# Access Compliance Report

### (Curb Ramps)

Intersection ID: 18792	Main Street: BARCLAY_DOWNS_DR	Cross Street: SAGAMORE_RD	Location: SW
ADA ID: 36403A408C8C	Ramp Type: PerpDiag	Initial Pass/Fail: Fail	Overall Compliance: No
Severity Score: 12.5			
Codes/Mitigation Info/Possible Solution		Field Measurements/Component Compliance

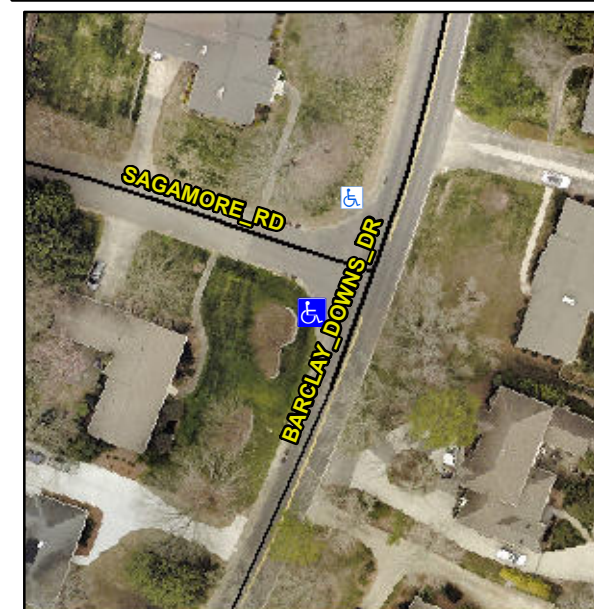
**Not Found, R304.2.2**

Compliance	Description	Data	Compliance	Description	Data
N/A	Ramp Length (in)	54.0	No	Ramp Slope (%)	10.1
Yes	Ramp Width (in)	48.0	Yes	Ramp XSlope (%)	1.2
N/A	Flare Type LT	N/A	N/A	Flare Type RT	N/A
N/A	Flare Slope LT (%)	N/A	N/A	Flare Slope RT (%)	N/A
N/A	Flare Traversable LT?	N/A	N/A	Flare Traversable RT?	N/A
N/A	Landing Length (in)	N/A	N/A	DWS Provided?	N/A
N/A	Landing Width (in)	N/A	N/A	DWS Contrast?	N/A
N/A	Landing Slope (%)	N/A	N/A	DWS Length (in)	N/A
N/A	Landing X Slope (%)	N/A	N/A	DWS Full Width?	N/A
N/A	Landing Curb? (Y/N)	N/A	N/A	DWS Offset (in)	N/A
N/A	Shared Landing?	N/A			
N/A	Gutter Ponding?	Yes	N/A	Gutter Slope (%)	N/A
N/A	Gutter Lip Ht (in)	N/A	N/A	Gutter X Slope (%)	N/A
N/A	Painted X Walk1?	No	N/A	Painted X Walk2?	No
	X Walk 1 Direction	To E		X Walk 2 Direction	To NE
N/A	X Walk 1 Width (in)	N/A	N/A	X Walk 2 Width (in)	N/A
	X Walk 1 Slope (%)	4.7		X Walk 2 Slope (%)	2.9
	X Walk 1 X Slope (%)	0.3		X Walk 2 X Slope (%)	1.2

**Remove & Replace Curb Ramp With Two New Directional Ramps or Equivalent.**
